SERVICE LETTER 20-64

DATE: March 10, 1960
SUBJECT: Carburetor Air Box - Inspection and Rework
MODELS AFFECTED: Noted in Each Part
TIME OF COMPLIANCE: Noted in Introduction to Each Part

Inspection and replacement of carburetor air box valve. Models affected - M-20 Serial Nos. 1002-1151.

FIGURE I

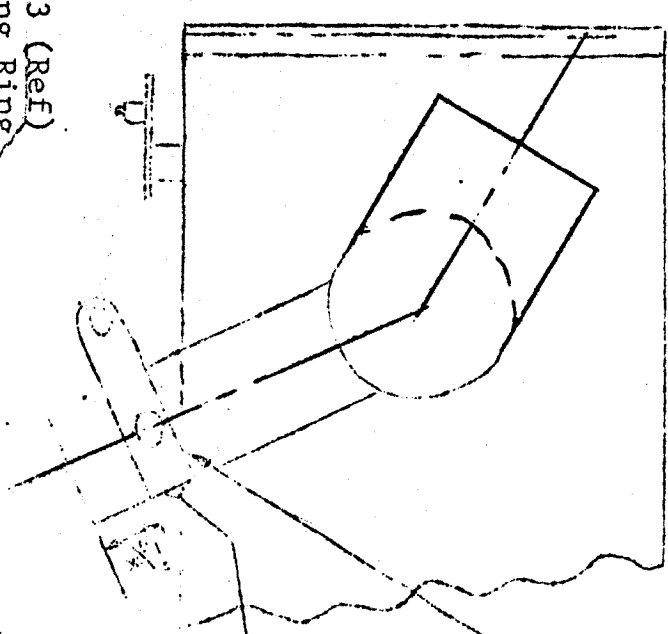
(1) Remove Carburetor Air Filter P/N 6382 and inspect Valve P/N 6175 for cracks as shown in Figure 1.

(1) Replace old valve with new P/N 6175 valve.

FIGURE 2

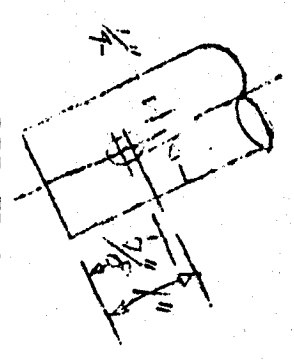
- (1) Remove left hand side cowl and inspect dump control P/N 6214 for wear and P/N 6186 for binding as shown in Figure 2.

- (1) Remove old Carburetor Dump Valve P/N 6214.
- (2) Install Kit S. L. 20-64-2 as shown in Figure 2.

- (1) Inspect P/N 6176 for looseness as shown in Figure 2.

- (1) Remove P/N 6176 (2 places).
- (2) Install Kit S. L. 20-64-3 as shown in Figure 2.

Relocate Bearing Ring P/N 6213
As Shown

Replace 4x $\frac{1}{2}$ Screw
With AN 470 A3
Install this side.

See Detail B for relocation of Bearing Ring P/N 6213

P/N 6186 Hot Air Dump Valve
Inspect for binding of valve.

P/N 6385 Air Dump Control
Replaces P/N 6214

Install 1/16 Welding Rod so that
P/N 6186 Fully Closed When
P/N 6175 is Fully Closed.

611/6 (2) (Ref)
Inspect for Looseness
(See Detail A for Repair)

DETAIL B
Elongate Hole in Air
Dump Tube

6432 (2)
Holes (2) of 6432
Match Existing
Holes in Air Box

DETAIL A
Install Kit S.L. 20-64-3
6432 Replaces 6176
AN 470A3 (8)
(Rivet Heads Inside Box)
